Project	IEEE 802.16 Broadband Wireless Access Working Group < http://ieee802.org/16 >
Title	For comment#1012: Adjusting figure 17c – GPCS Layering Model
Date Submitted	2006-05-10
Source(s)	Achim Brandt, Maximilian Riegel Siemens AG Achim.Brandt@siemens.com
Re:	Showing figure 17c explicitly, with the changes proposed in Comment #1012
Abstract	Adjusting figure 17c by removing the boxes representing the interfaces for the particular protocols labeled 'IPv4 over 802.16', 'IPv6 over 802.16', 'IEEE802.3/Ethernet over 802.16', '802.1Q/VLAN over 802.16'. - Rename 'Multiple protocols over 802.16' into 'Multiple protocols encapsulation'
Purpose	For approval as part of Comment #1012
Notice	This document has been prepared to assist IEEE 802.16. It is offered as a basis for discussion and is not binding on the contributing individual(s) or organization(s). The material in this document is subject to change in form and content after further study. The contributor(s) reserve(s) the right to add, amend or withdraw material contained herein.

Protocol structure with the Generic Packet Convergence Sublayer (GPCS)

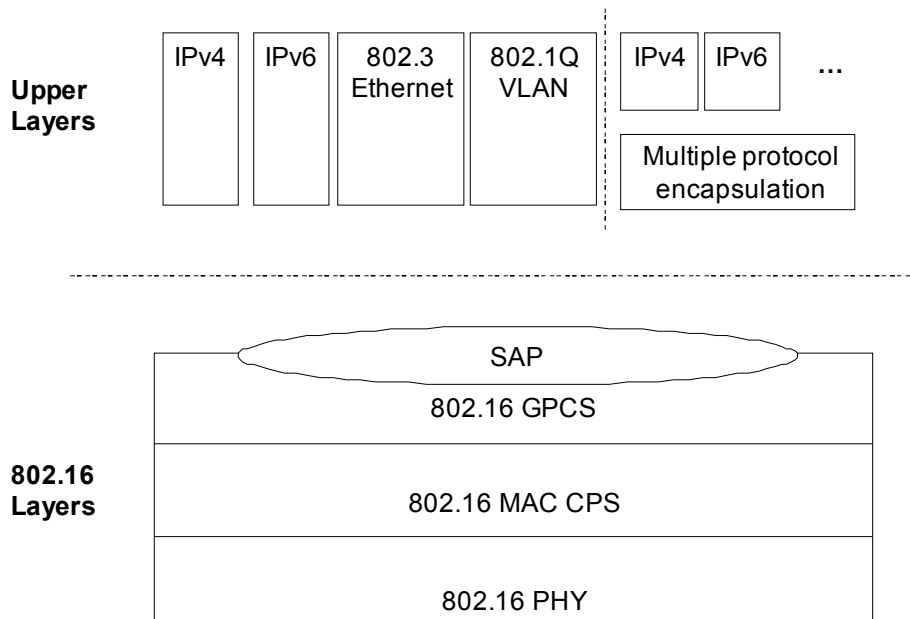
Comment #1012 proposes this remedy:

- Adjust figure by removing the boxes representing the interfaces for the particular protocols labeled 'IPv4 over 802.16', 'IPv6 over 802.16', 'IEEE802.3/Ethernet over 802.16', '802.1Q/VLAN over 802.16'.
- Rename 'Multiple protocols over 802.16' into 'Multiple protocols encapsulation'

Corresponding Change to figure 17c in 802.16g/D2, page 10
